TEAMSTERS CANADA RAIL CONFERENCE

USE OF JUMP SEATS

A REVIEW OF CP'S RESPONSE

BACKGROUND HISTORY & TCRC CONCERNS

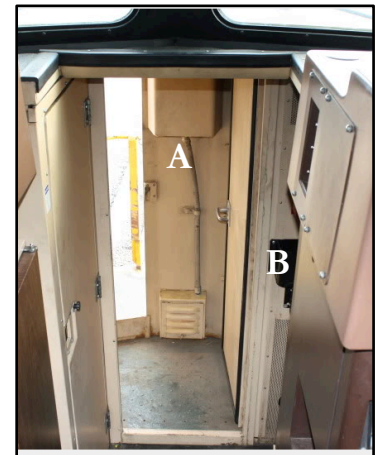
The locations identified by the company do not have any "luggage type" racks, and thus grips will have to be double stacked which can result in grips being crushed. Recently a conductor while travelling deadhead on VIA Rail, encountered an issue with their grip when the conductor was at the VIA Rail station checking in. The grip in question received secondary inspection by VIA Rail station staff, the bagged weighed in at 43 pounds, 3 pounds greater the VIA Rail's luggage regulations in the coach.

In addition, placing their grips in the outer alcove between the outer and inner door creates three issues:

1. This location is not environmentally controlled, and exposes any grip stored there to cold or heat. Refer to photo at right letter "A".
2. This location is the normal location for the tool rack, flagging kits and the stretcher. These items are all in secured positions, which prevents them from becoming a projectile or blocking the egress route of the front door. Grips placed in this location, in an accident situation will become dislodged from their resting position and impend the egress route. The inner door opens outwards from the operating position of the cab, thus in an accident event, the inner door could become blocked, restricting the front egress route. Photo at right shows the proposed alcove storage locations for grips and the outward swing of the inner cab door. Refer to photo at right letter "A". ¹²

3. Grips placed in "the alcove directly opposite the toilet compartment door" will also have to be stacked, allowing grips to be crushed. Again, in this location during an accident event, they can become dislodged and block an egress route. Refer to photo at right letter "B".
